In D3.1 we add the following functionality, and after simulating some parts and analyzing the changes we did, we found some errors in state machine and variable definitions that need to be corrected.

The intent of adding CLASSIFICATION\_PRI, CLASS\_PROBE\_PRI and the exits to IDLE\_PRI and CLASS\_RESET\_PRI was to allow the following functionality:

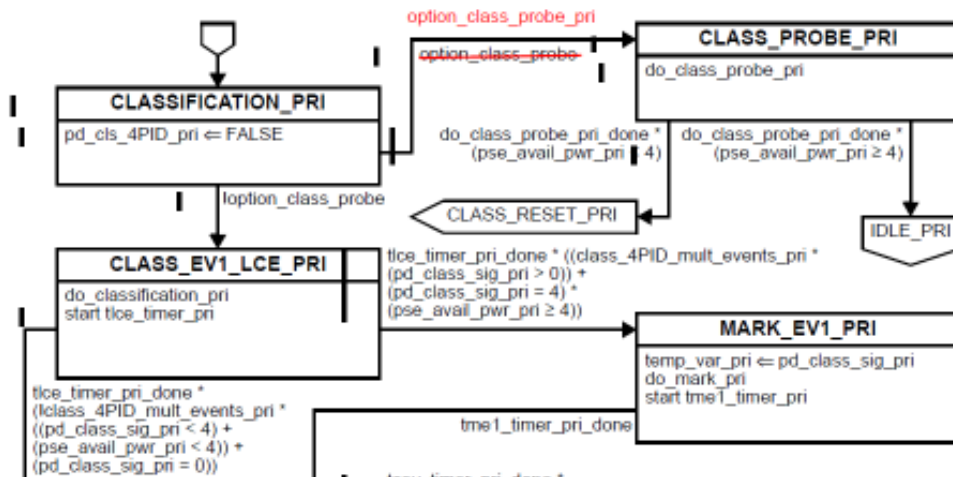
- h) Clause 145.2.5.6, page 131 line 5: Definition of do\_class\_reset function is missing for the high-level state machine.
- i) In the functions do\_classification, do\_classification\_pri and do\_classification\_sec, there are missing description of the need to perform class event etc.

do\_classification [This function produces the classification event voltage and determines the PD's class signature.](#) This function returns the following variable:....."

do\_classification\_pri [This function produces the classification event voltage and determines the PD's class signature for the Primary Alternative.](#) This function returns the following variables for the Primary Alternative:

do\_classification\_sec [This function produces the classification event voltage and determines the PD's class signature for the Secondary Alternative.](#) This function returns the following variables for the Primary Alternative:

3. change the following state machine for the primary and secondary as shown for the primary.

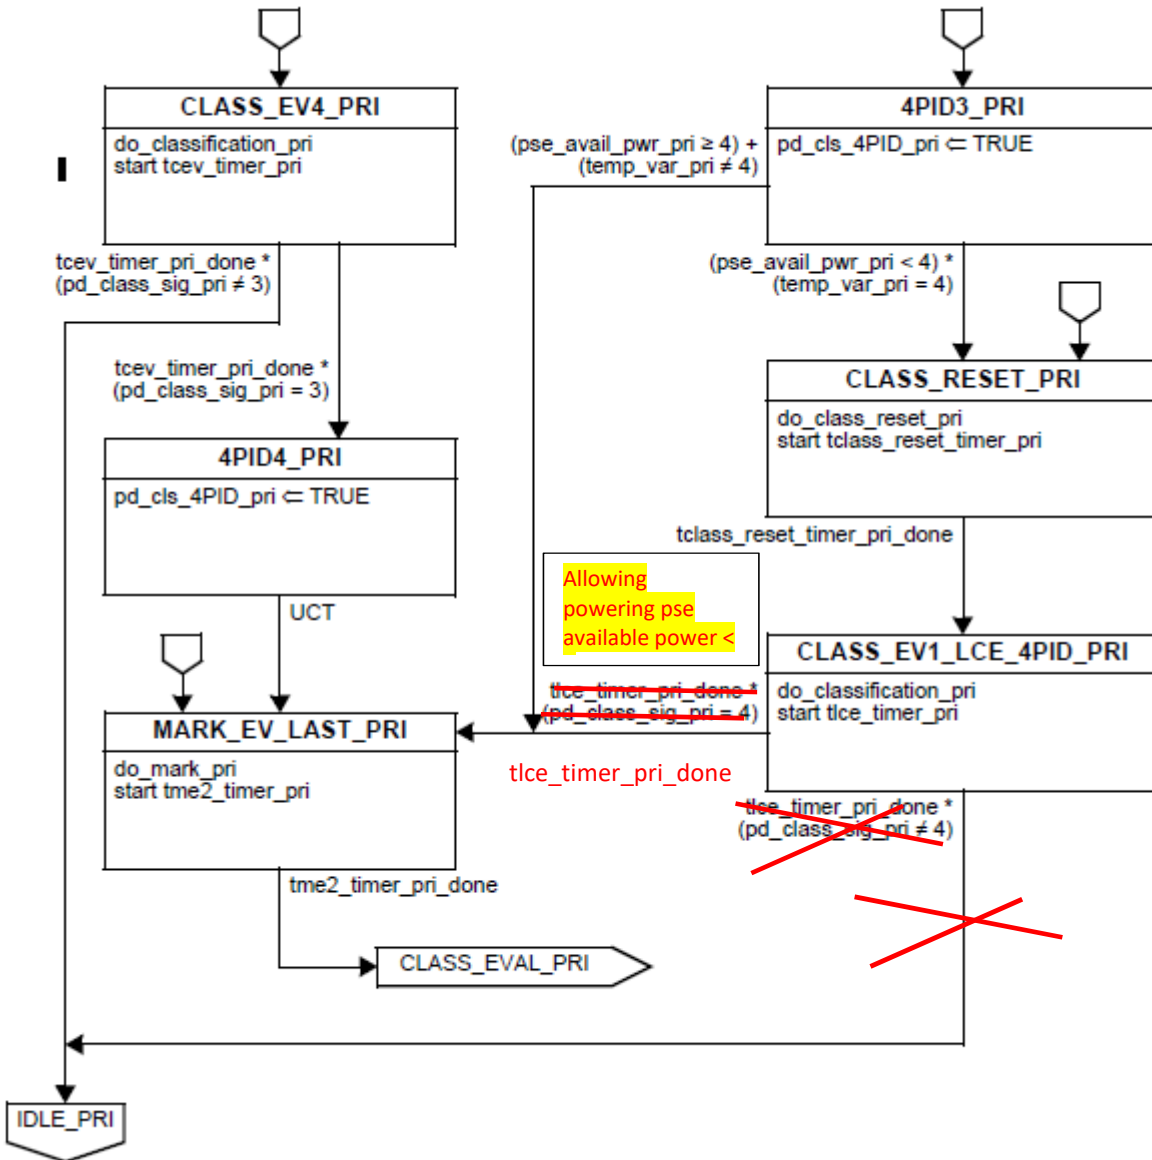
- d) This item was deleted.
- e) The intent when doing CLASS\_PROBE\_PRI with 3 short class events when  $pse\_avail\_pwr\_pri < 4$  was to go to class reset and then to single long class event and then power up. Now in D3.1, If option\_class\_probe is set, state machine will either go to IDLE\_PRI or to CLASS\_RESET\_PRI and from CLASS\_RESET\_PRI eventually to IDLE\_PRI instead of continuing towards MARK\_EV\_LAST\_PRI and powering the port while allowing powering with only single long class event and not twice. This is not working. [See Annex C for details.](#)

If option\_class\_probe is set and pse\_avail\_pwr\_pri<4, the state machine will either go to IDLE\_PRI or to CLASS\_RESET\_PRI and from CLASS\_RESET\_PRI through CLASS\_EV1\_LCE\_4PID\_PRI eventually to IDLE\_PRI instead of continuing to MARK\_EV\_LAST\_PRI towards powering the port, which is an error (The intent was to allow powering while doing only single long class event and not twice as we had in D3.0. **Now it will not power at all regardless the route we take from CLASS\_EV1\_LCE\_4PID\_PRI.**

**The result is no matter what we do when available power<4 (and PD class is 1-3) we can't go to MARK\_EV\_LAST and continue towards power up!**

The solution: To flip the exits from CLASS\_EV1\_LCE\_4PID\_PRI to allow powering PDs with class 1 to 3 that matches pse\_avail\_pwr\_pri<4 after doing CLASS\_RESET\_PRI.

1. **Change the exit from CLASS\_EV1\_LCE\_4PID\_PRI to MARK\_EV\_LAST\_PRI from:**

tlce\_timer\_pri\_done \* (pd\_class\_sig\_pri = 4) to: tlce\_timer\_pri\_done \* (pd\_class\_sig\_pri ≠ 4)

2. **Change the exit from CLASS\_EV1\_LCE\_4PID\_PRI to IDLE\_PRI from:**

tlce\_timer\_pri\_done \* (pd\_class\_sig\_pri = 4) to: tlce\_timer\_pri\_done \* (pd\_class\_sig\_pri = 4).

5. change the following state machine for the primary.

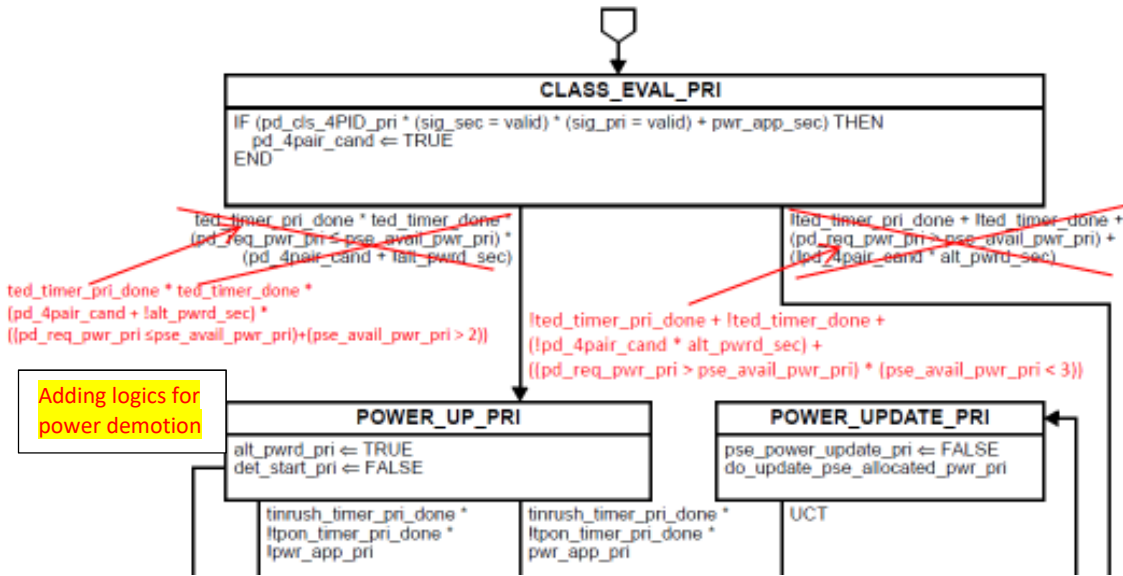
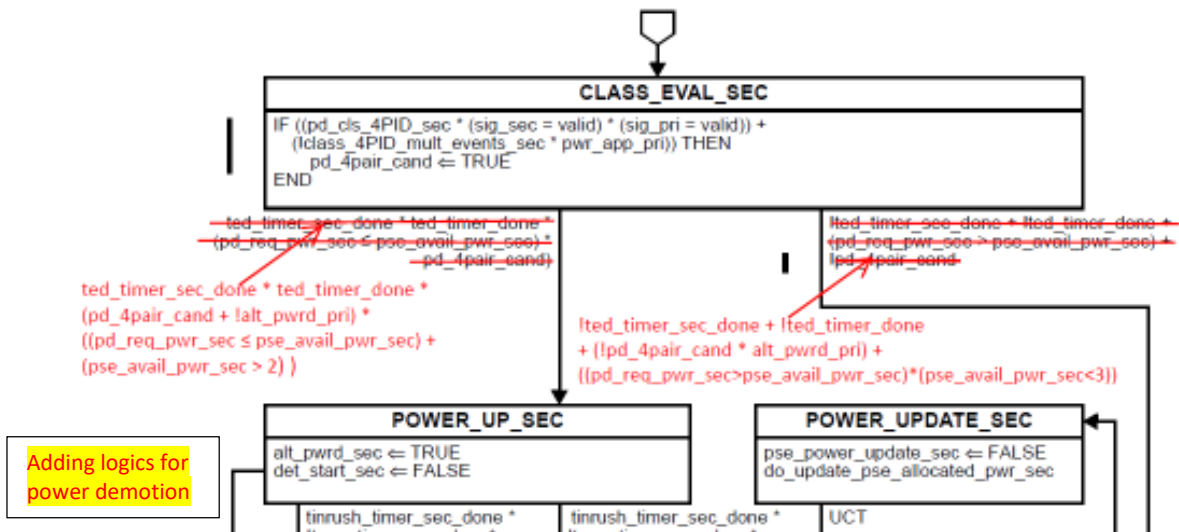
- f) Missing logic for power demotion in the exits from CLASS\_EVAL\_PRI (and CLASS\_EVAL\_PRI). [See Annex D.](#)
- g) All the above issues are the same for the secondary as well.

Looking at the high-level single-signature state machine and use the logics for power demotions with the necessary changes for dual-signature.

### 1. Change the exit from CLASS\_EVAL\_PRI to POWER\_DENIGED\_PRI from:

$!ted\_timer\_pri\_done + !ted\_timer\_done + (pd\_req\_pwr\_pri > pse\_avail\_pwr\_pri) + (!pd\_4pair\_cand * alt\_pwr\_sec)$

To:

$!ted\_timer\_pri\_done + !ted\_timer\_done +$   
 $(!pd\_4pair\_cand * alt\_pwr\_sec) +$   
 $((pd\_req\_pwr\_pri > pse\_avail\_pwr\_pri) * (pse\_avail\_pwr\_pri < 3))$

### 2. Change the exit from CLASS\_EVAL\_PRI to POWER\_UP\_PRI from:

$ted\_timer\_pri\_done * ted\_timer\_done * (pd\_req\_pwr\_pri \leq pse\_avail\_pwr\_pri) * (pd\_4pair\_cand + !alt\_pwr\_sec)$

To:

$ted\_timer\_pri\_done * ted\_timer\_done *$   
 $(pd\_4pair\_cand + !alt\_pwr\_sec) * ((pd\_req\_pwr\_pri \leq pse\_avail\_pwr\_pri) + (pse\_avail\_pwr\_pri > 2))$

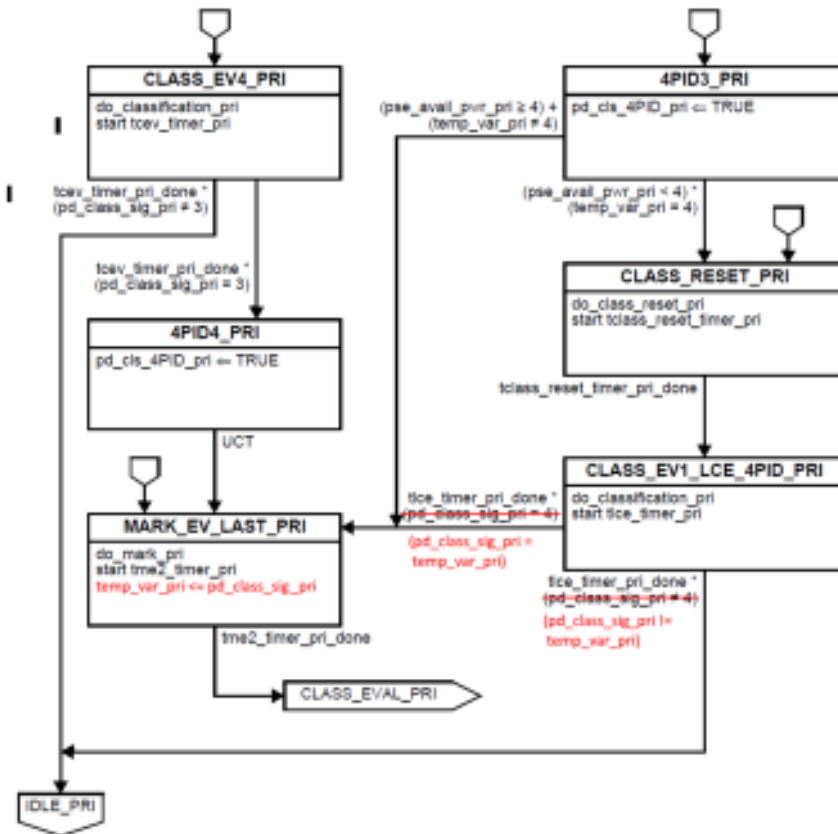
## Annex E – Derivation or power demotion logics for the secondary

### 1. Change the exit from CLASS\_EVAL\_SEC to POWER\_DENIGED\_SEC from:

$!ted\_timer\_sec\_done + !ted\_timer\_done + (pd\_req\_pwr\_sec > pse\_avail\_pwr\_sec) + !pd\_4pair\_cand$

To:

$!ted\_timer\_sec\_done + !ted\_timer\_done + (!pd\_4pair\_cand * alt\_pwr\_pri) +$   
 $((pd\_req\_pwr\_sec > pse\_avail\_pwr\_sec) * (pse\_avail\_pwr\_sec < 3))$

### 2. Change the exit from CLASS\_EVAL\_SEC to POWER\_UP\_SEC from:

$ted\_timer\_sec\_done * ted\_timer\_done * (pd\_req\_pwr\_sec \leq pse\_avail\_pwr\_sec) * pd\_4pair\_cand$

To:

$ted\_timer\_sec\_done * ted\_timer\_done *$   
 $(pd\_4pair\_cand + !alt\_pwr\_pri) * ((pd\_req\_pwr\_sec \leq pse\_avail\_pwr\_sec) + (pse\_avail\_pwr\_sec > 2))$
